Our ref: 11129
Council ref: A006807199

RE: CHANGE APPLICATION (MINOR CHANGE) - *SECTION 81 OF THE PLANNING ACT 2016* - 9 OVEREND STREET, EAST BRISBANE, 31 WELLINGTON ROAD, EAST BRISBANE AND 33 WELLINGTON ROAD, EAST BRISBANE (A006807199)

The application seeks to amend the approved development to incorporate a range of changes arising from the detailed design process. The amendments include refinements to the building form, internal layouts, servicing, landscaping and façade treatments, while maintaining the overall intent and character of the approved development. The application also seeks to remove the approved Short-term Accommodation use from the development approval and amend the public art contribution requirement. Overall, the proposed changes reflect a combination of detailed design refinements and amendments to approved land use

Building Height

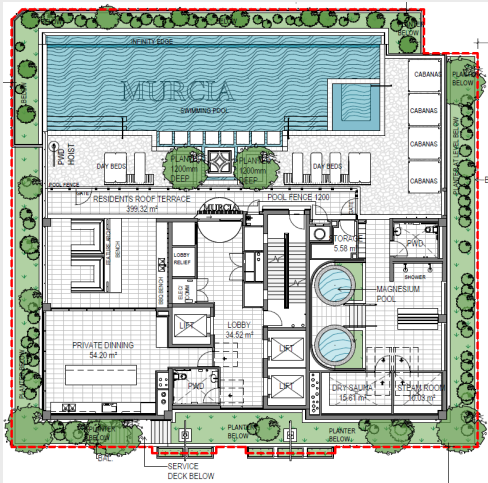
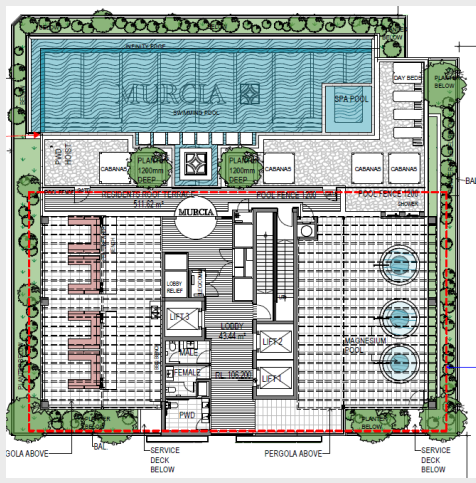
As part of this minor change, the Applicant proposes a reduction in the overall building height from RL109.5m to RL106.8m. Notably, the approved and proposed reduced levels remain unchanged from Ground Level through to Level 19, with changes to the vertical levels commencing above Level 19.

Given the minor nature of the height reduction and the location of the changes, the development will appear substantially the same from surrounding public vantage points. As such, the proposed amendment does not result in any material change to the visual character or built form outcome of the approved development.

Figure 1: Extract of deep planting area along Wellington Road

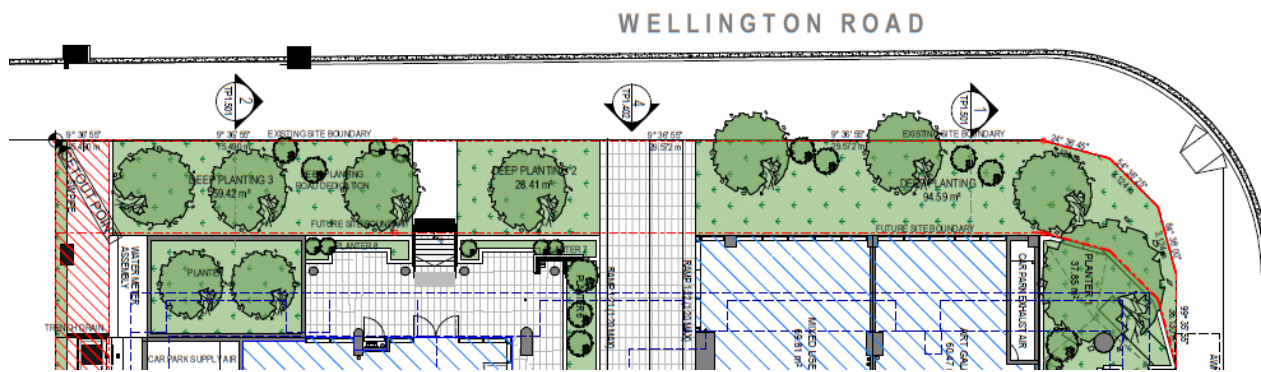
The proposed change seeks to remove the street awning located above the deep planting zone along the development frontage. An extract of the proposed deep planting area is provided in **Figure 1**, which demonstrates that the deep planting zone extends beneath the entire length of the awning. As such, the awning is positioned directly over the proposed tree planting and does not provide meaningful shade to the adjoining pedestrian footpath.

The removal of the awning will provide the proposed trees with unrestricted growing conditions, allowing for the establishment of larger, healthier and more resilient canopies over time. This will result in a superior long-term outcome, including increased shade provision, improved pedestrian comfort, enhanced visual amenity and a more substantial green frontage. In this regard, the proposed amendment prioritises the long-term success of the deep planting and landscape strategy, rather than relying on a built structure that is located directly above the planting area and provides limited benefit to pedestrians.

Additional Storeys

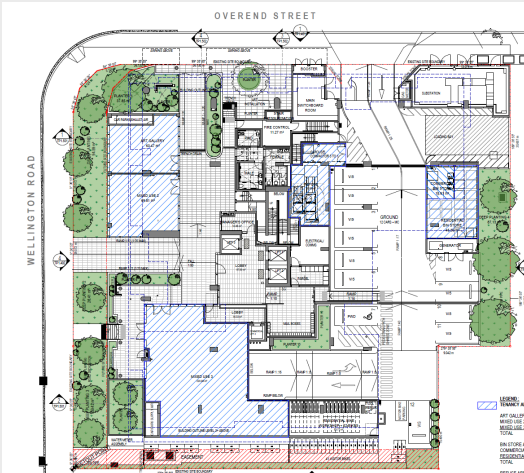
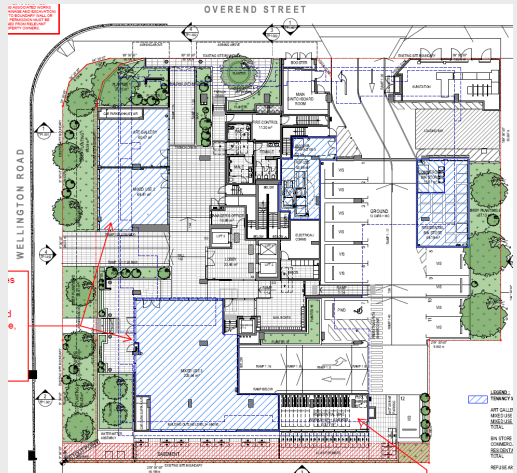
As part of the detailed design process, the rooftop recreation facilities have been refined to improve functionality, usability and resident amenity. The approved design incorporated predominantly open-air rooftop facilities, including pergola structures and associated communal recreation areas. The proposed design introduces additional roofed communal facilities, including a private dining area and enclosed wellness amenities, resulting in a more functional and weather-protected rooftop recreation space.

- Refinements to the layout, including the relocation of cabanas, sun lounges and magnesium plunge pools.
- Reduction of one magnesium plunge pool.
- Introduction of a private dining area.

As a consequence of these changes, the rooftop level is now captured by the definition of a storey due to the introduction of roofed communal facilities.

Ground

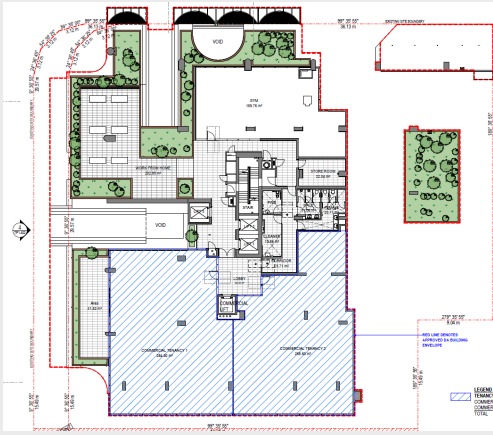
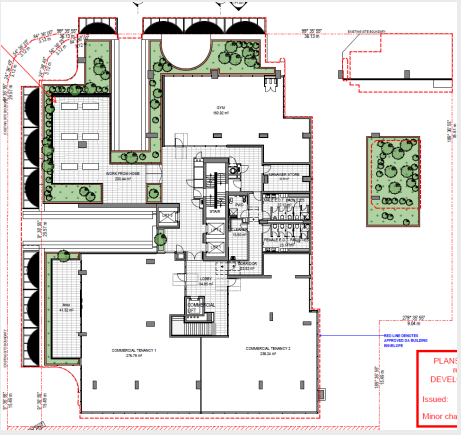
The minor change to the Ground Level includes a number of minor amendments to the internal layout, allocation of floor area and landscaping. The internal changes generally relate to refinements to the lobby, mixed use and service areas, with some areas increasing and others reducing in size.

The landscaping changes are also minor in nature and include adjustments to seating, tactile indicators, turf, boulders, gravel and bin locations along the Overend Street and Wellington Road frontages.

Aspect	Proposed	Approved
Layout		
Layout Comparison	▪ Lobby – 106m² ▪ Mixed Use 3 – 220.98m² ▪ Residential Bin Storage – 46.36m² ▪ Fire Control – 11.27m² ▪ Visitor Bike Spaces – 41 ▪ Tactile indicators along access driveway	▪ Lobby – 33.46m² ▪ Mixed Use 3 – 225.44m² ▪ Residential Bin Storage – 59.19m² ▪ Fire Control – 11.20m² ▪ Visitor Bike Spaces – 42 ▪ Seating near Overend street entrance ▪ Seating near mixed use tenant

Level 16

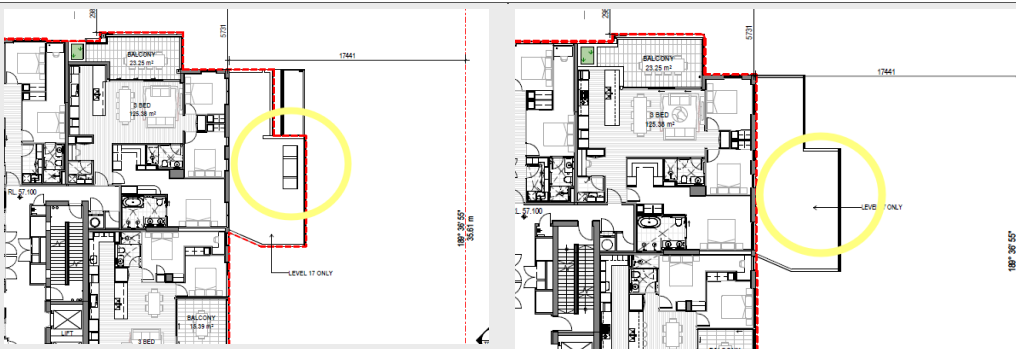
The minor change to Level 16 includes a number of refinements to the communal and residential outdoor areas, together with minor landscaping amendments. The changes include the removal of the fire pit and associated built-in seating, replacement of the hot tub with a spa and pool, removal of the pergola over the north-eastern apartment's outdoor area, and minor adjustments to the landscaping, including one fewer canopy tree and an additional climber to the southern trellis. There are no changes to the number of units or the size of the units on this level. Overall, the changes are minor in nature and maintain the broader approved arrangement of the level.

Aspect	Proposed	Approved
<i>Layout</i>		
<i>Layout Comparison</i>	▪ Removal of the fire pit and associated built-in seating. ▪ Replacement of the hot tub with a combined spa and pool. ▪ Removal of the pergola over the north-eastern apartment's outdoor area. ▪ Minor landscaping refinements, including the removal of one canopy tree. ▪ Addition of a climber to the trellis along the southern portion of the site.

Level 21

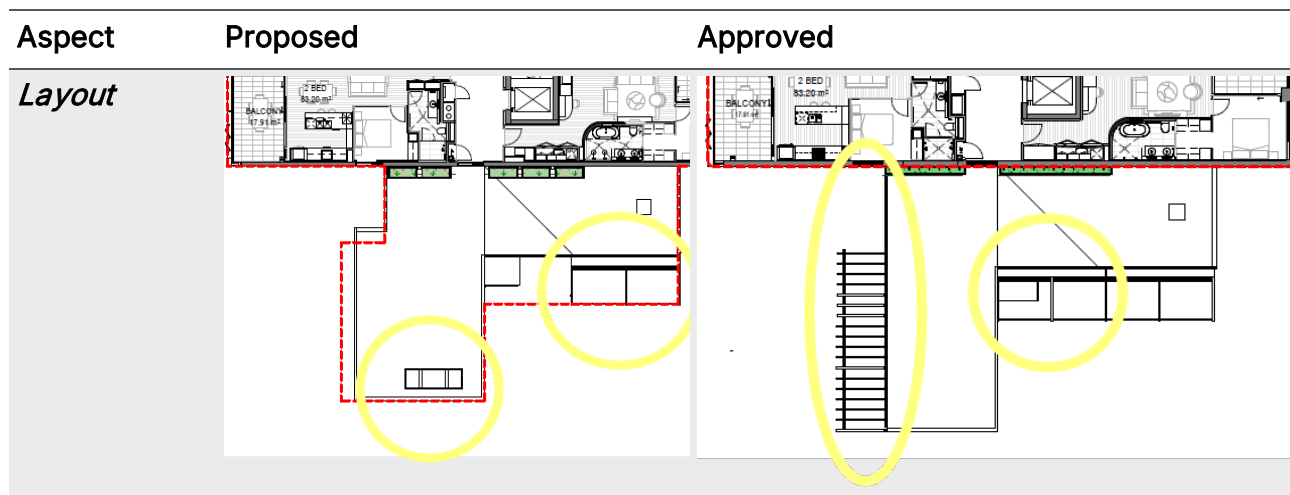
The minor change to Level 21 includes a number of refinements to the balcony arrangements, together with adjustments to the size and internal layout of the apartments and lobby area. The changes have been made as part of the detailed design process and generally relate to minor refinements to the internal and external configuration of the level. The changes also include the removal of the pergola, with the area now provided as a roofed structure, the introduction of a sauna and pool, associated turf and gravel landscaping, and the identification of stairs on the plans.

- Removal of the pergola, with the area now provided as a roofed structure.
- Minor refinements to the internal layout.
- Introduction of a sauna and pool, together with associated turf and gravel landscaping.
- Stairs now identified on the plans for clarity.

Level 22

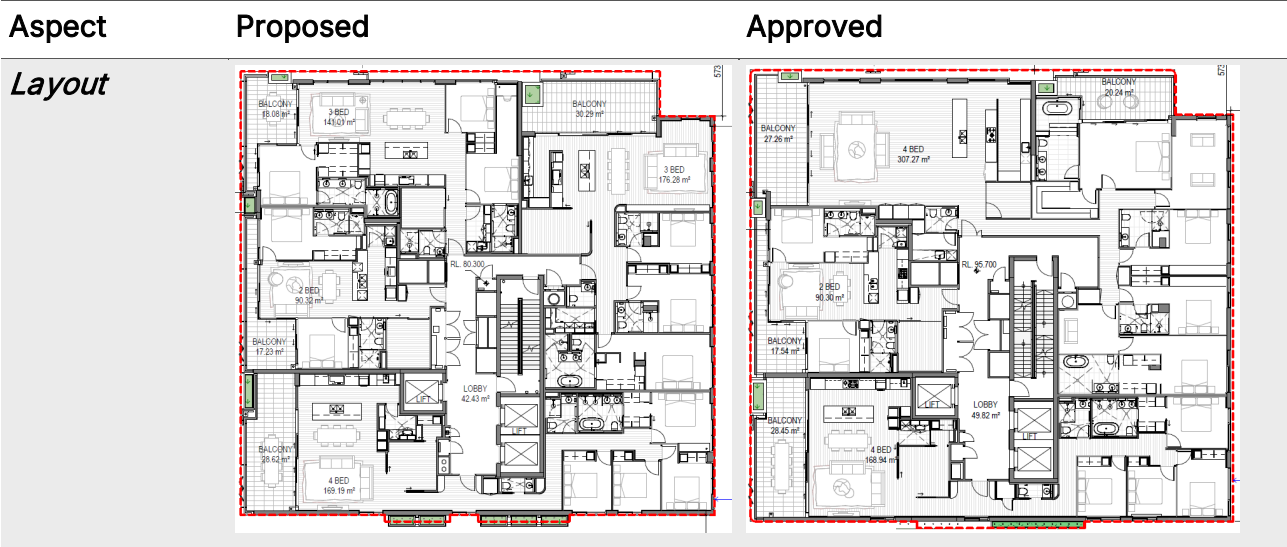
At Level 22, the proposed amendments primarily relate to minor refinements to the apartment layouts, lobby area and roof structures. As demonstrated in the comparison table below, the changes to the apartments are minor and generally relate to small adjustments to unit and balcony areas. The lobby area has also been slightly reduced.

The roof amendments include the conversion of previously proposed pergola structures to roofed structures, together with the incorporation of a small screened plant zone. Overall, the changes to Level 22 are minor in nature and do not materially alter the approved arrangement or overall built form. A detailed comparison of the approved and proposed layout is provided in the table below.

- Minor refinements to the apartment layouts, including small changes to unit, balcony areas and lobby
- Previously proposed pergola structures amended to roofed structures.
- Small screened plant area added at roof level.

Level 24-28

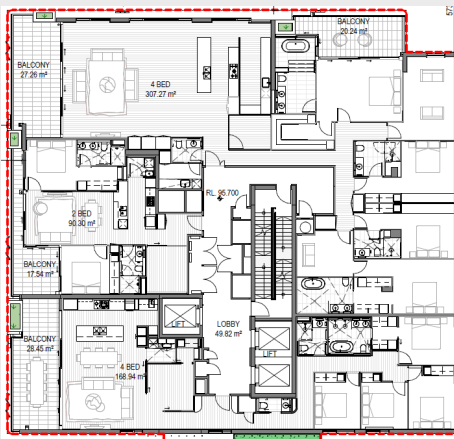
The revised Level 28 arrangement comprises two three-bedroom apartments, one two-bedroom apartment and one four-bedroom apartment. This provides a more consistent apartment layout across the upper levels and makes more efficient use of the available floor plate, while retaining the established residential function and overall built form of the approved development. The amendment is therefore primarily a refinement to the internal apartment configuration, with no change to the overall number of storeys. A detailed comparison of the approved and proposed layouts is provided in the table below.

The existing approved plans show Level 28 with 3 units instead of 4. However, the new layout mirrors levels 24-27, providing two 3-bedroom, one 2-bedroom and one 4-bedroom apartments.

Level 29

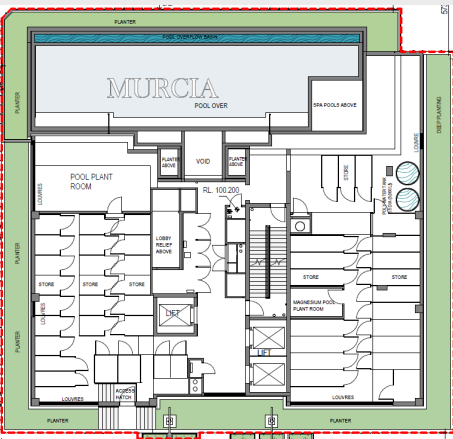
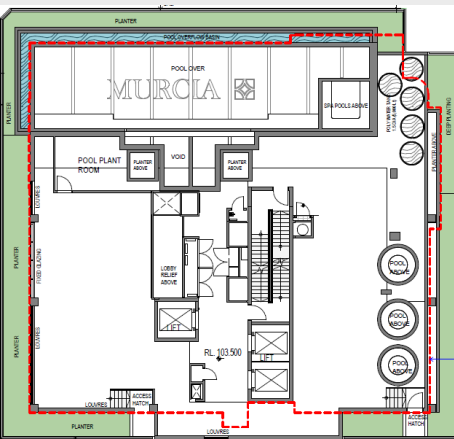
At Level 29, the proposed changes are limited to minor refinements to the internal apartment configuration, including adjustments to the size of the apartments and lobby area. These amendments reflect the progression of the detailed design while maintaining the overall layout, residential function and character of the approved level. No substantive changes are proposed to the broader arrangement at this level.

No.	Proposed		Existing	
	Unit	Balcony	Unit	Balcony
1	317.75m ²	27.26m ² + 20.24m ²	307.27m ²	27.26m ² + 20.24m ²
2	90.30m ²	17.54m ²	90.30m ²	17.54m ²
3	168.94m ²	28.45m ²	168.94m ²	28.45m ²
Lobby	42.66m ²		49.82m ²

Level 30 – Services

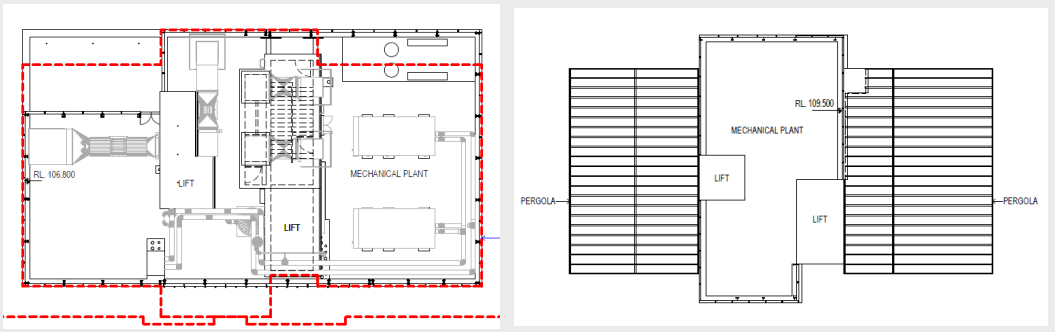
The changes to the Level 30 services area include the addition of storage cages, together with minor adjustments to the internal layout to accommodate the additional storage provision. These refinements make more efficient use of the existing service and storage areas while maintaining the overall function of the level. No other substantive changes are proposed to the Level 30 services arrangement, which remains generally consistent with the approved development.

Aspect	Proposed	Approved
<i>Layout Comparison</i>	Introduction of storage cages.

Figure 2: Proposed Plant Trellis

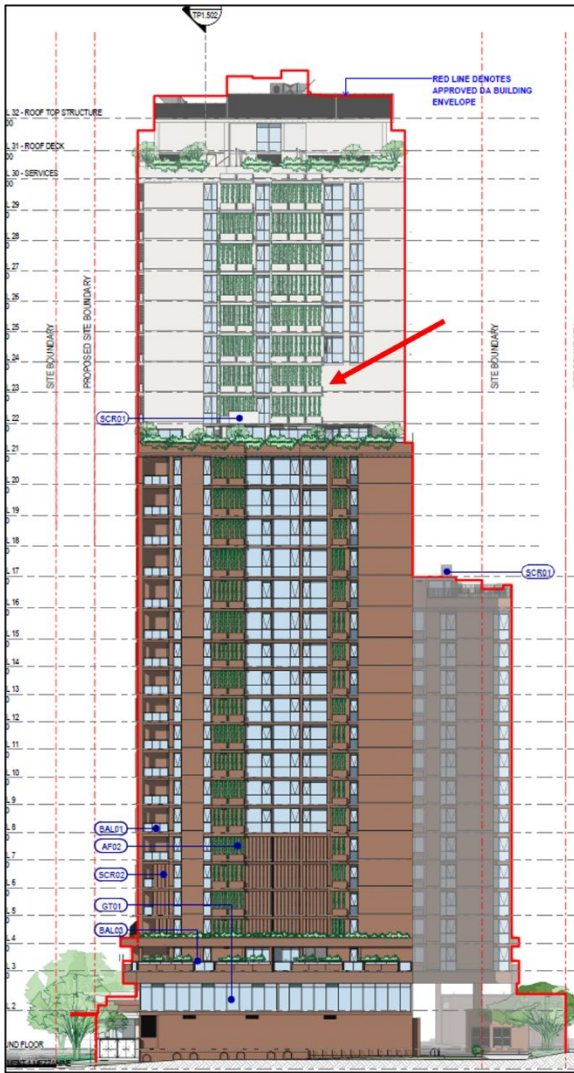
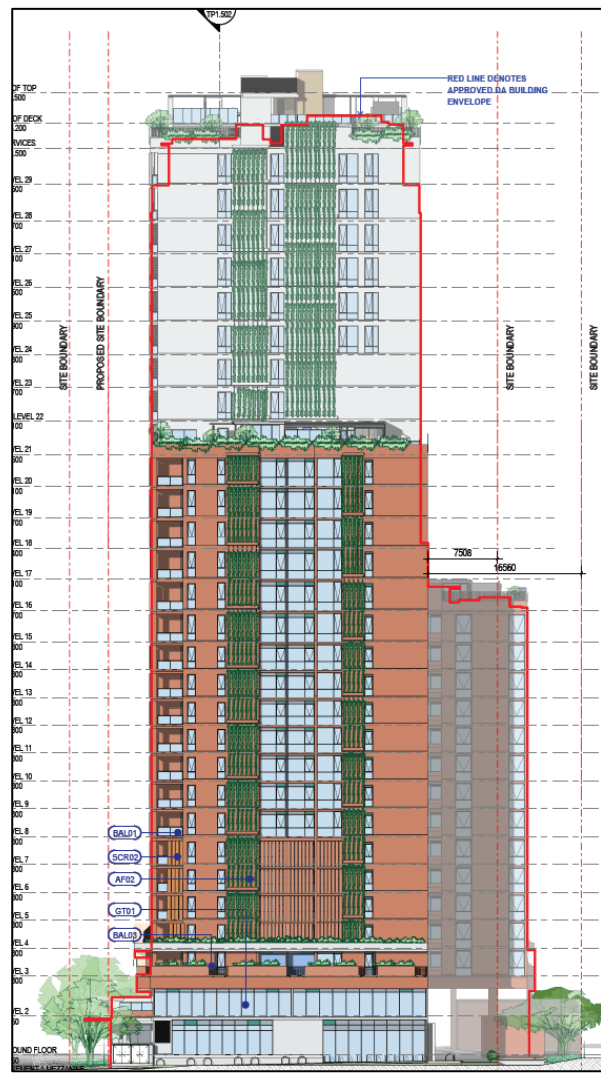
The southern elevation has been refined through the increased provision of trellis planters across the majority of the residential levels. While the approved design incorporated trellis planters at every second level, the proposed arrangement provides additional planting at more frequent intervals along the façade.

This increased provision will create a more consistent and cohesive landscape treatment, providing greater greenery and plant coverage across the southern wall. The change is considered an improved outcome, assisting in softening the building façade and strengthening the integration of landscaping into the overall architectural presentation.
